CHANGE ORDER

Project: Woodland High School Project No.: 1119.00-12
 Architect: McGranahan Architects Change Order No.: 3
 Contractor: Skanska USA Building, Inc. Date: March 12, 2014

Sheet No. C5.03

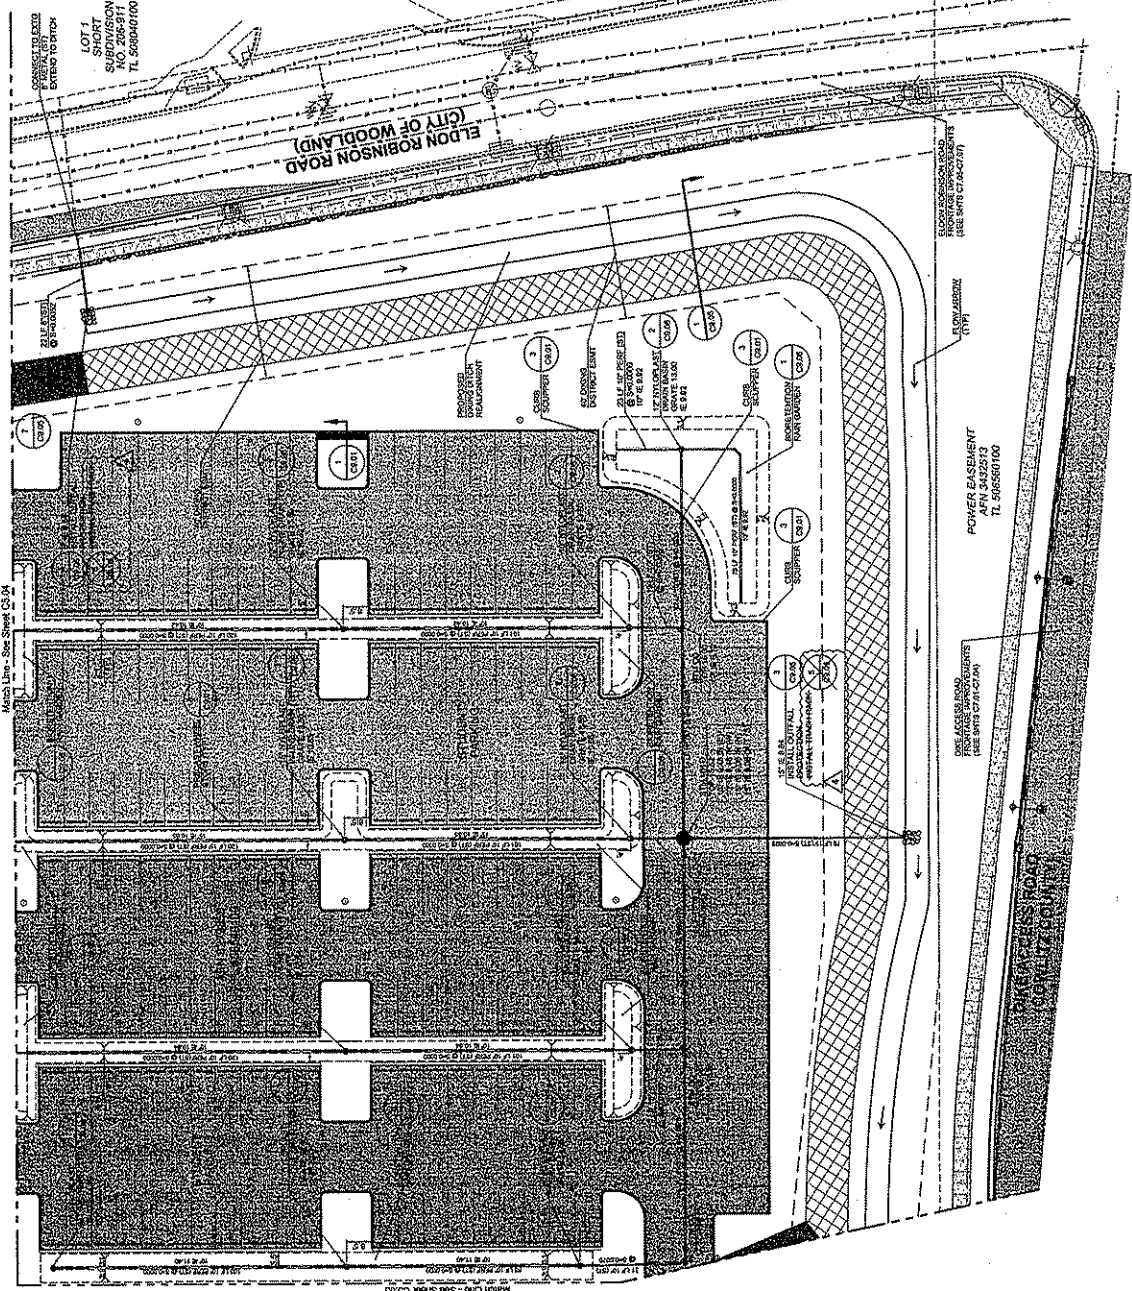
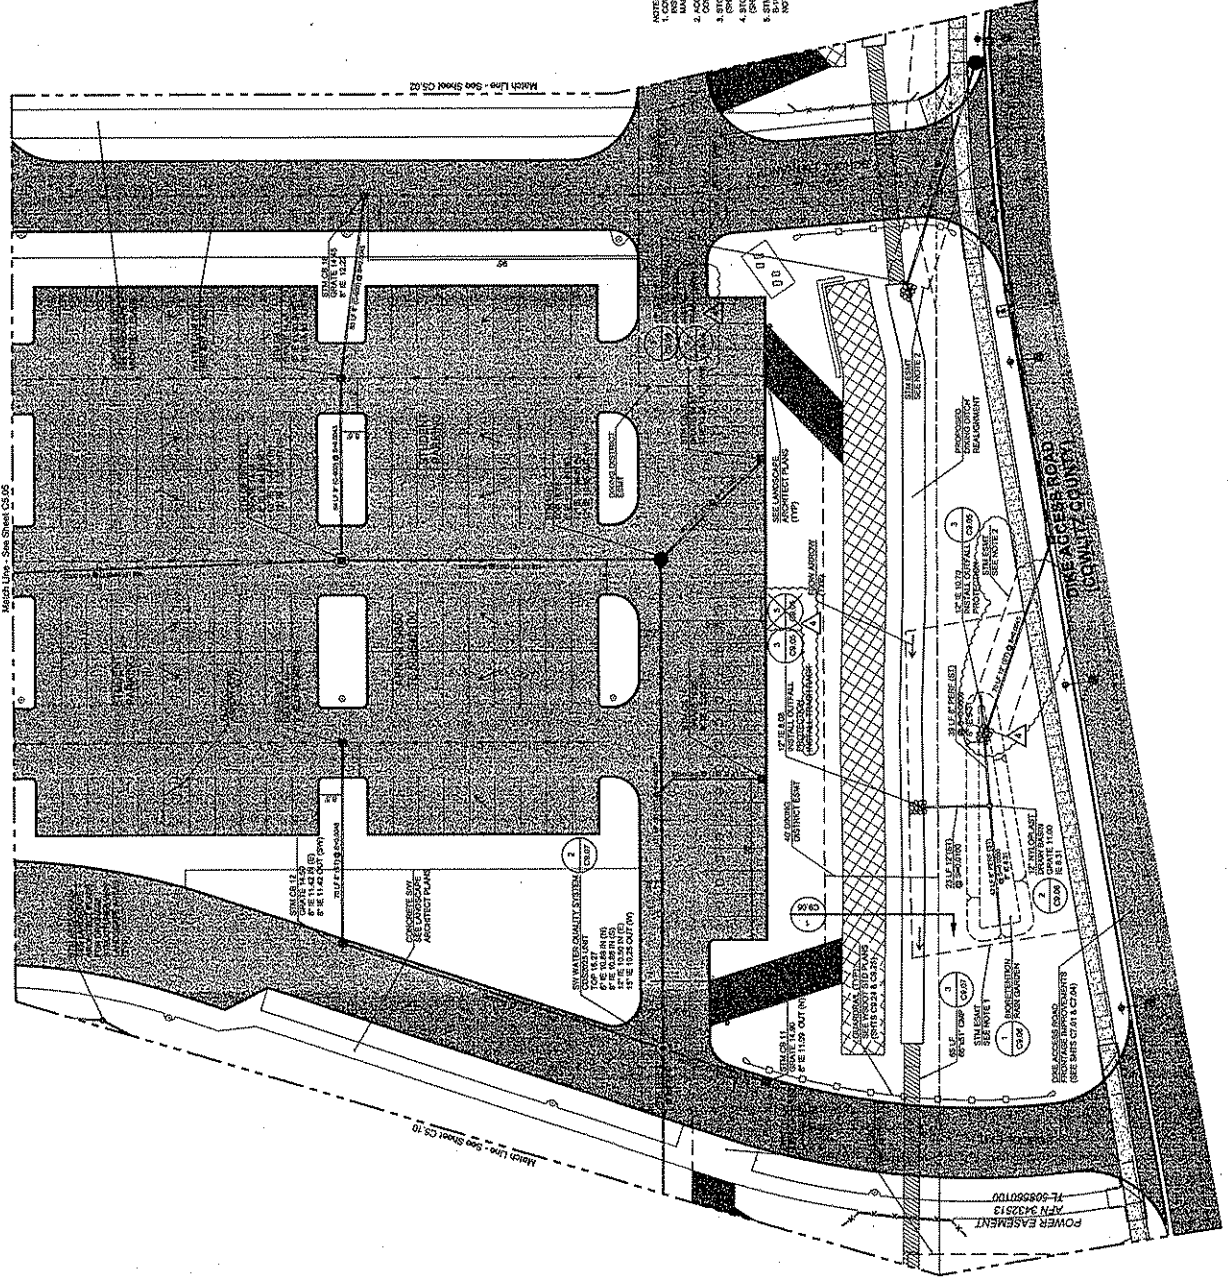
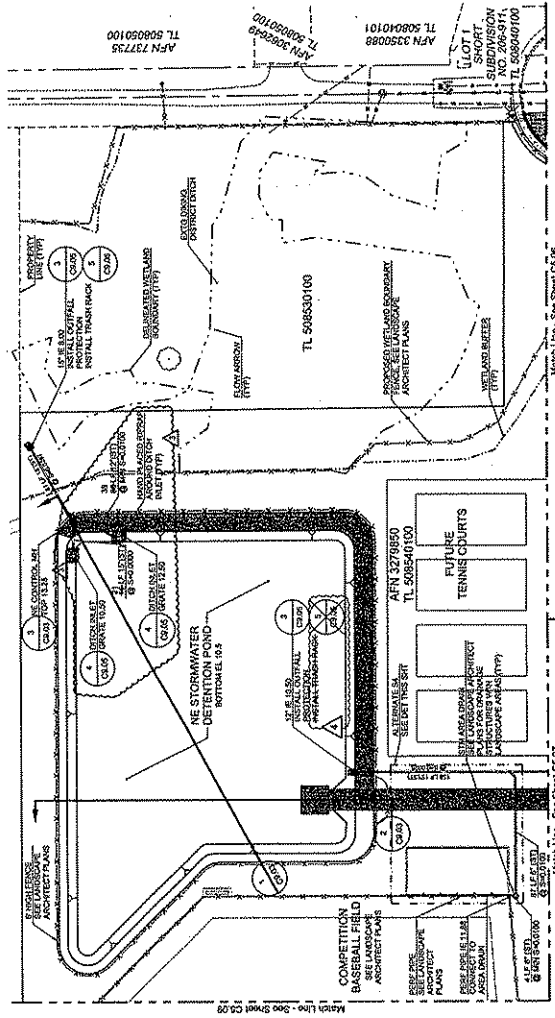
- 1. Make changes to the work identified in Volume 1 Drawings by a "Delta 4" designation.
- 2. Delete trash rack per CSK-023,

TITLE: PARTIAL ROOF FRAMING PLAN - COMMONS

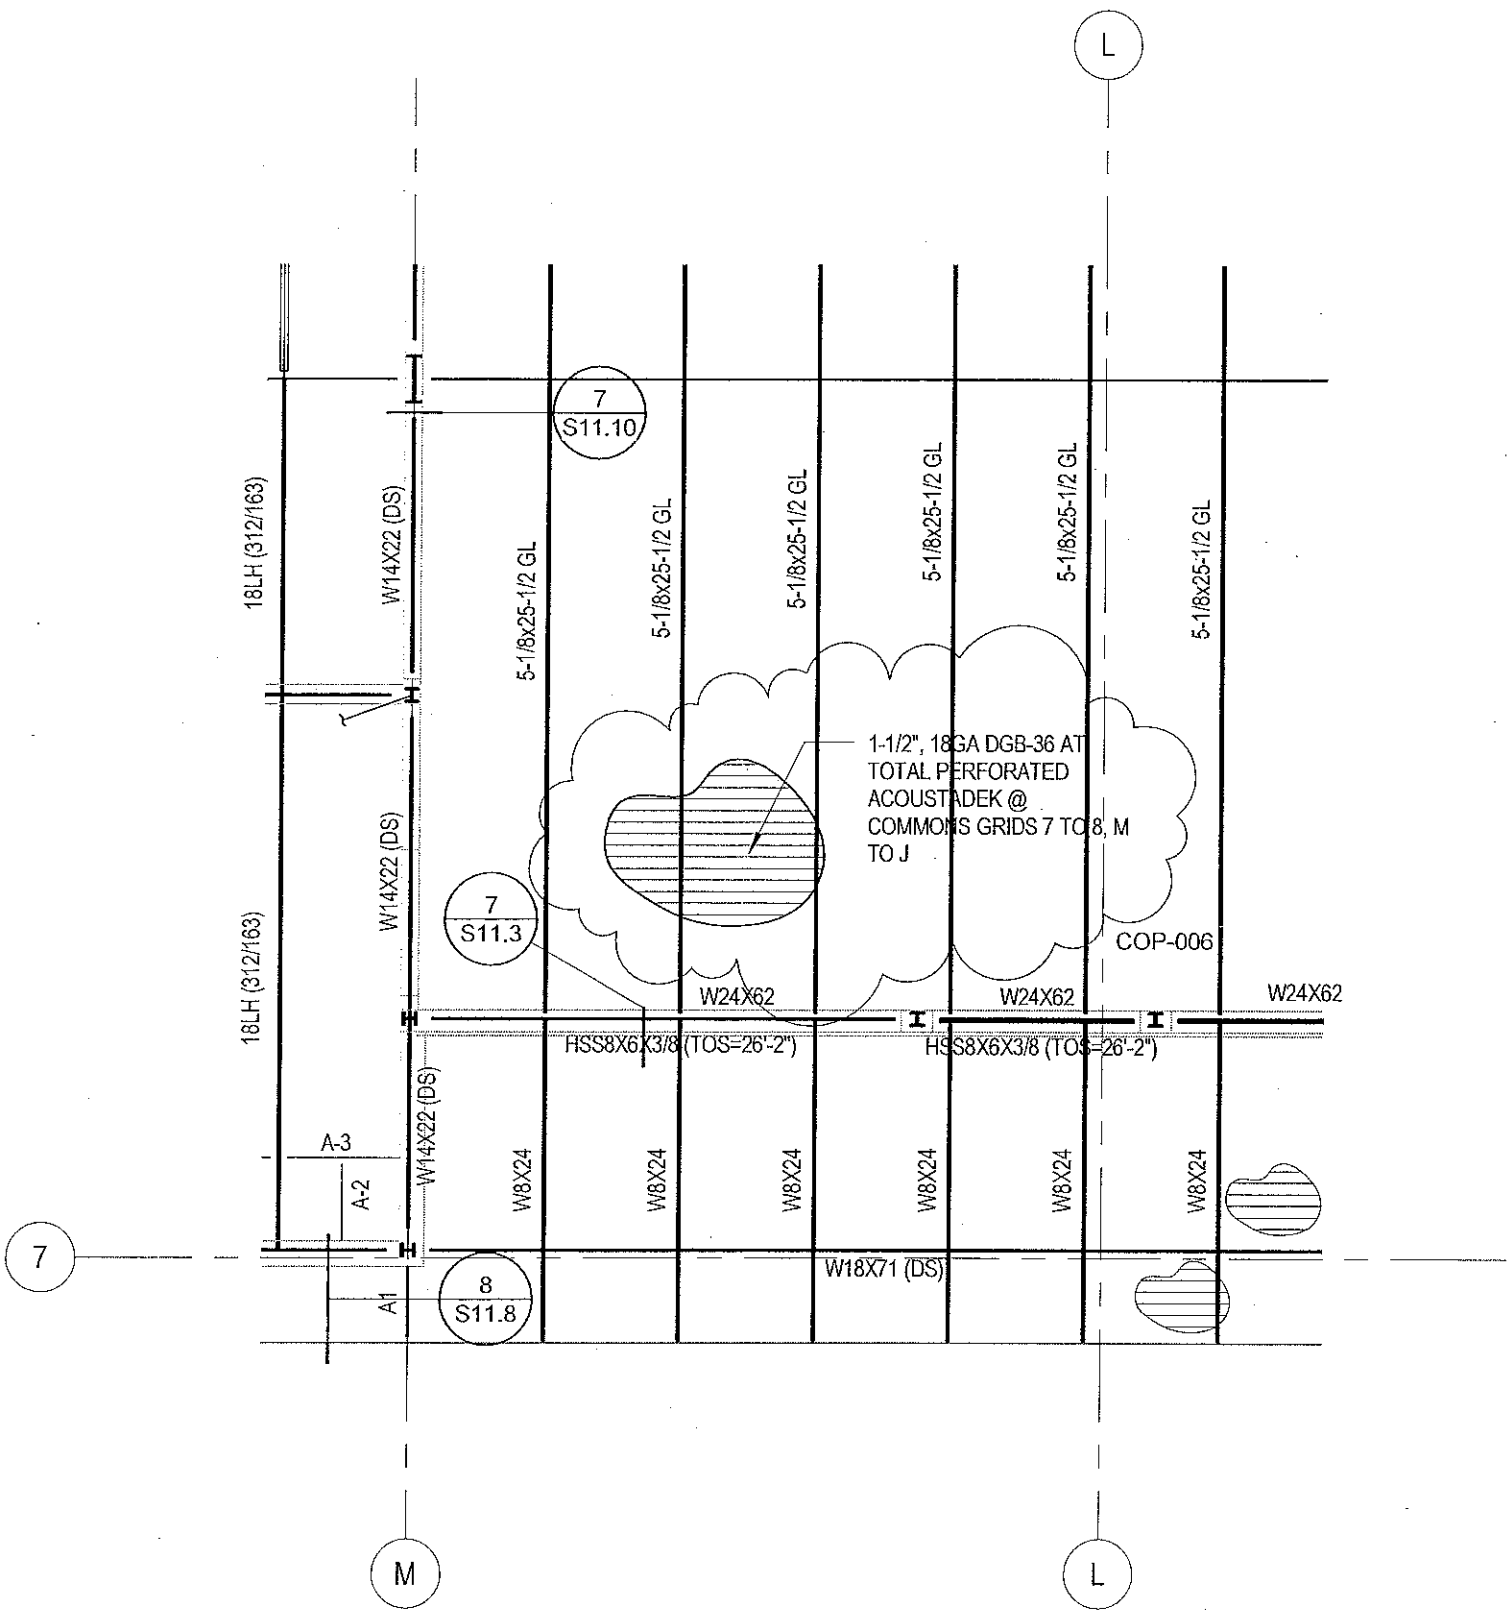
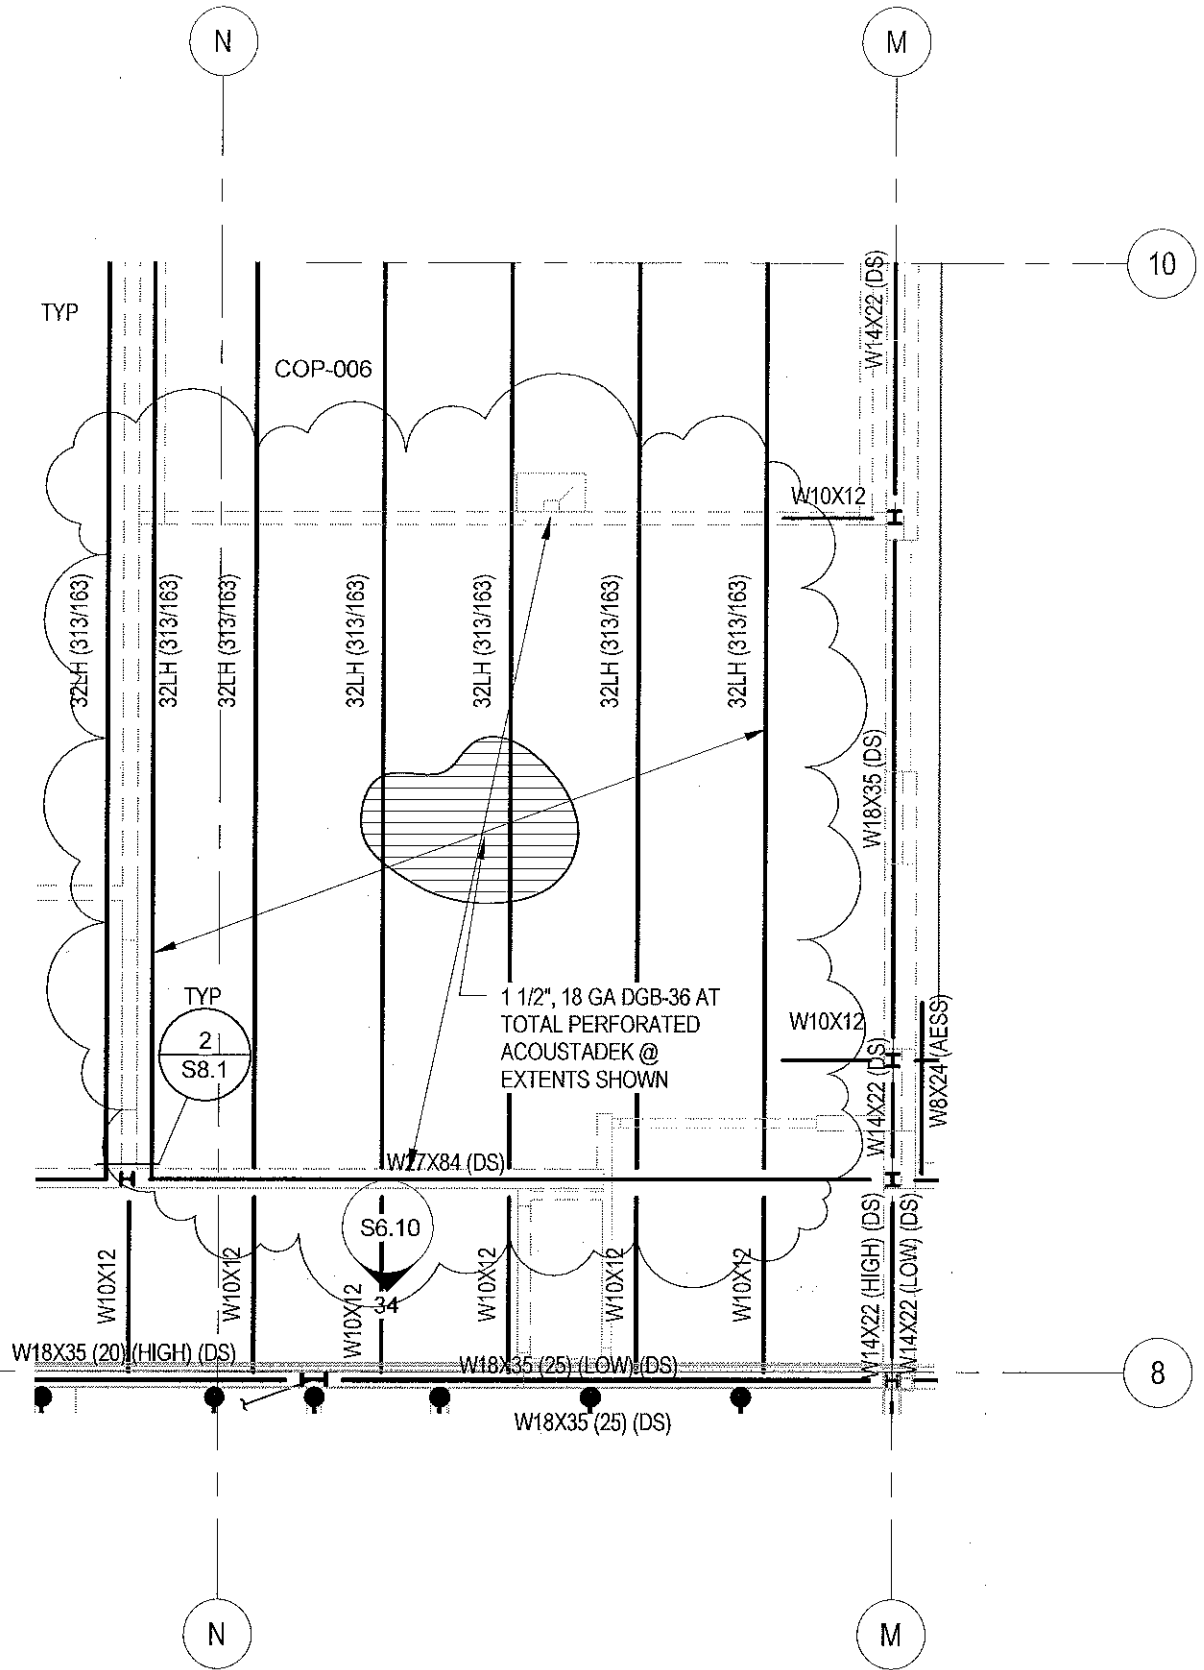
- 1. Revise the extent of perforated roof deck at the Commons per SSK-SSK-077.
- 2. Provide perforated roof deck above Culinary Arts Lab 1601 per SSK-SSK-078.
- 3. Provide perforated roof deck north of grid 7 at the Wrestling/ Fitness area per SSK-SSK-079.

TITLE: PARTIAL FIRST FLOOR PLAN

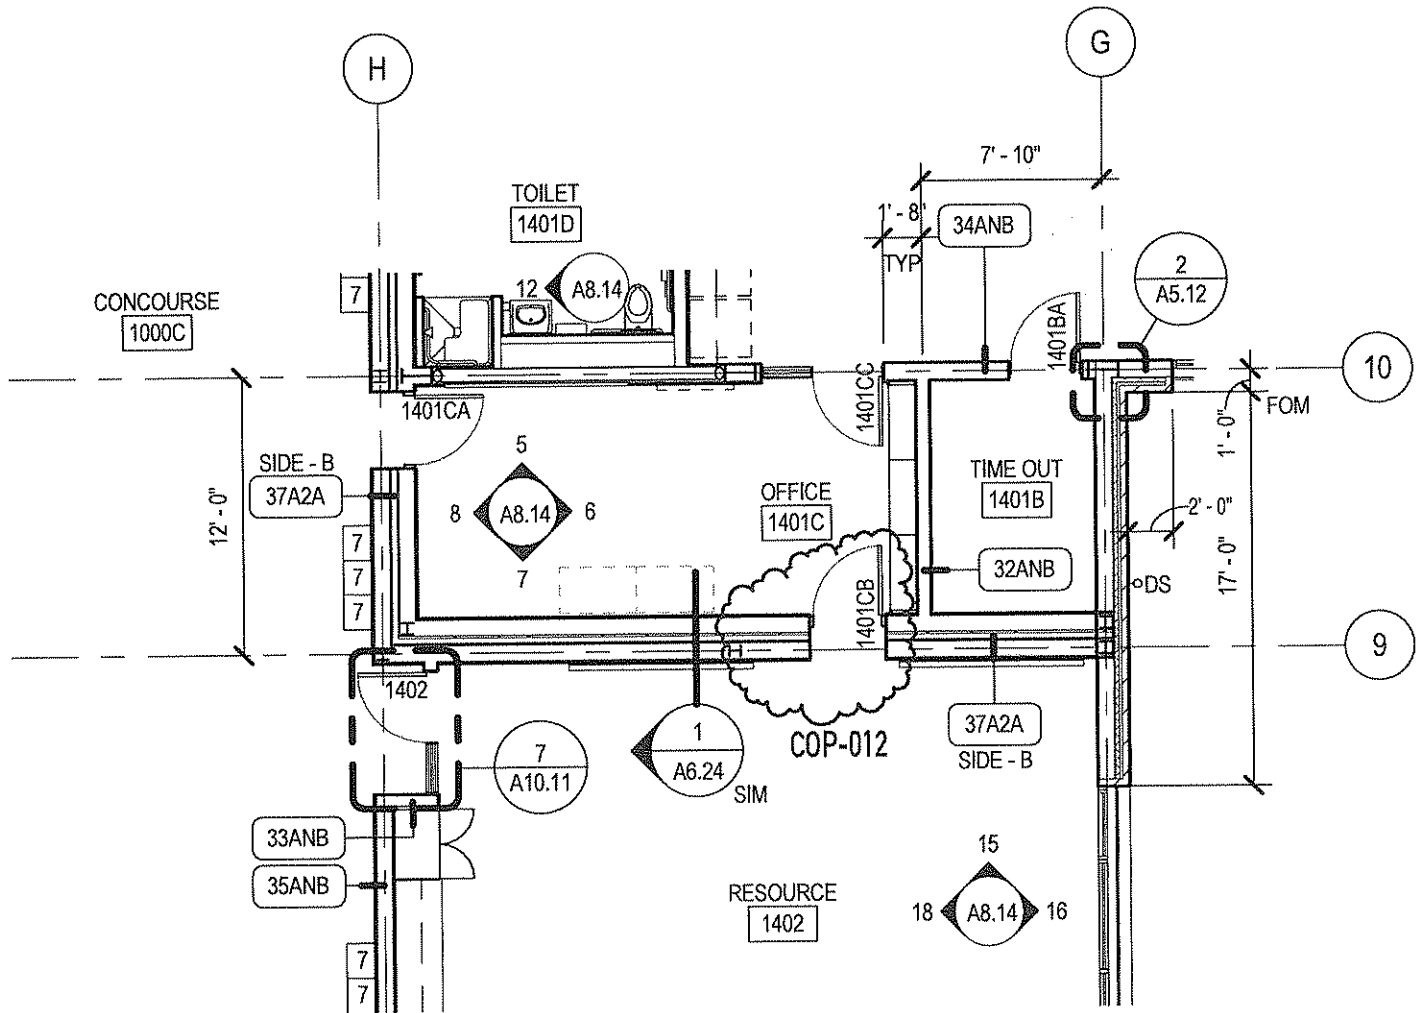
- 1. Change frame at door 1401CB from Type 15 to Type 2.
- 2. Change door from Type A to Type B.

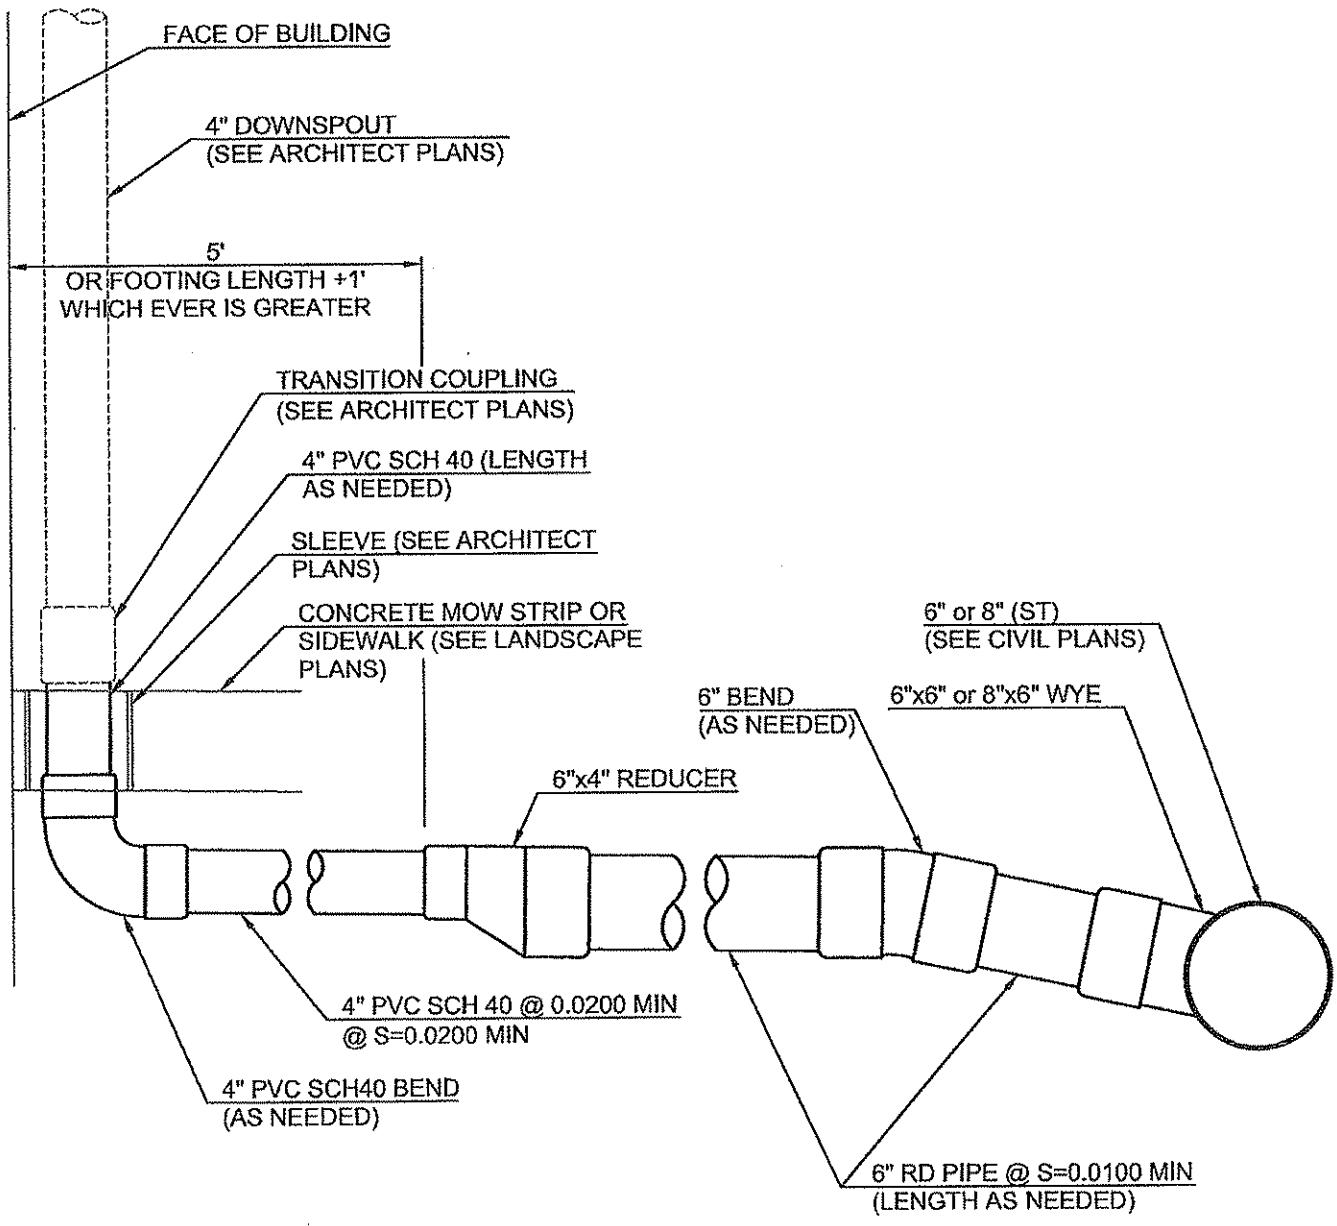
Reference Civil C5.04-C5.07: Please provide a detail for the roof drain connections (RD Connection) referenced on the civil plans. Also, please confirm pipe size from the 6" and 8" laterals to the connection.

HDJ- Response: The attached sketch CSK-32 details (clarifies) the RD connection, pipe sizes and types. Maureen White, P.E. HDJ DESIGN GROUP, PLLC 1/28/14

Section 07 71 23 requires a galvanized pipe fabrication to cover the connection
Section 07 71 23 requires a downspout cap fabricated from steel plate and steel pipe (and galvanized) to be provided at the connection of the downspout to the tightline. Revised sheet A5.11 issued for CCD-003R1 shows a modified connection for this.
Steve Broback
1/29/14
